Minerals Inspection Report

| Mine Name: Bentonite Pits | Permit Number: | M/041/0012 | Mine Status: | active |
| Inspection Purpose: Check Revegetation status of two north pits | | Prior Inspection: | | |

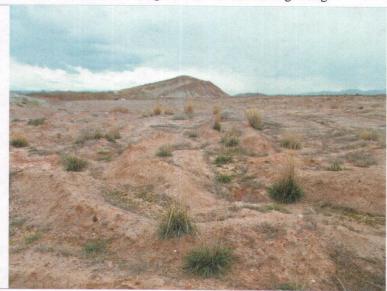
The Expanson pit had virtually no desirable vegetation. there was some halogeton and russian thistle growing on this area. It was evident from the surface cracking that this was a heavy clay soil. This entire pit will need to be reseeded. (see steps outlined in #6)

North Sheep Trail Expanson Pit (reclaimed) only small amounts of halogeton and Russian thistle growing.
